SUBJECT: HI-STORM 100, AMENDMENT 2, HIGH HEAT LOAD THERMAL  
EVALUATION (TAC NO. L23657)

**HI-STORM 100 Cask System  
Docket Number 72-1014  
Amendment Request 2  
Thermal Evaluation of Proposed High Decay Heat Load**

**THERMAL EVALUATION**

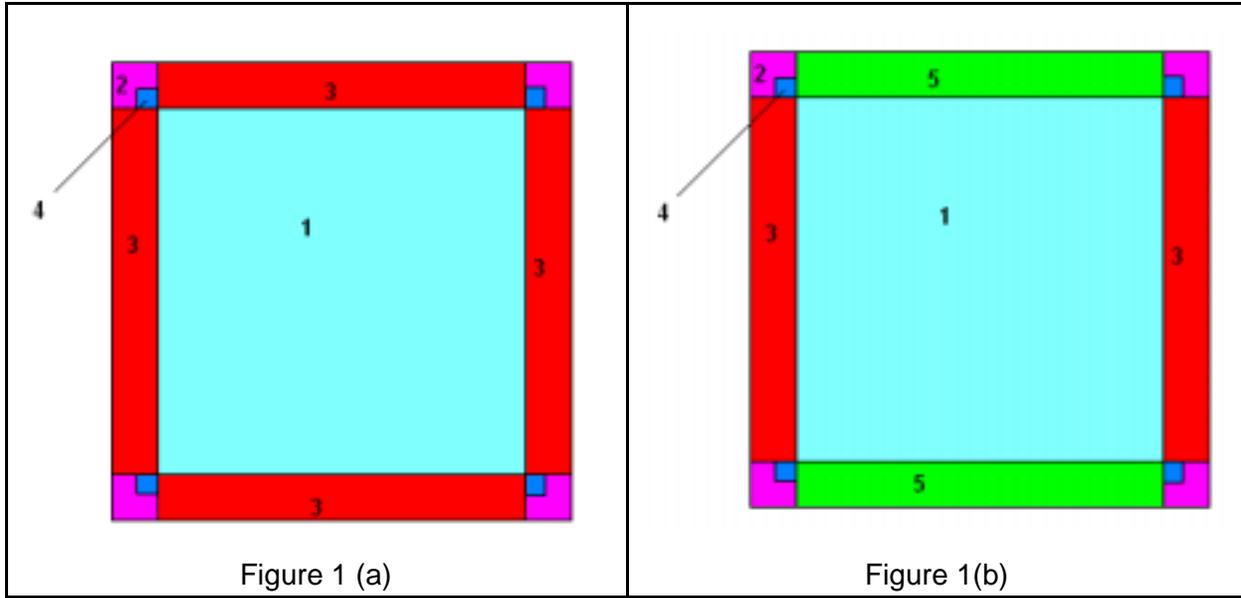
Directional effective thermal conductivity values of the composite basket wall-neutron absorber-sheating sandwich are obtained by the applicant considering a series (out-of-plane) and parallel (in-plane) approach. In the lateral out-of-plane direction heat is transported across layers of

sheating, helium gap, neutron absorber and basket wall series resistances. Heat conduction in the longitudinal in-plane direction is through an array of parallel resistances of the layers listed above. These non-isotropic thermal conductivities are determined by the use of two-dimensional (2-D) ANSYS finite element temperature results combined with a one-dimensional heat conduction equation applied for each direction (in-plane and out-of-plane).
